Addendum 15 – Regulation No. 16

Revision 8 – Amendment 4

07 series of amendments — Date of entry into force: 22 June 2017

Uniform provisions concerning the approval of:

Model A

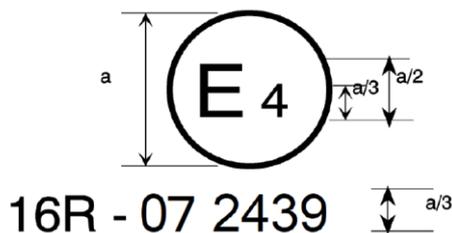
Annex 2, amend to read:

The above approval mark affixed to a vehicle shows that the vehicle type concerned has, with regard to safety-belts, been approved in the Netherlands (E 4) pursuant to

Regulation No. 16. The approval number indicates that the approval was granted according to the requirements of Regulation No. 16 as amended by the 07 series of amendments.
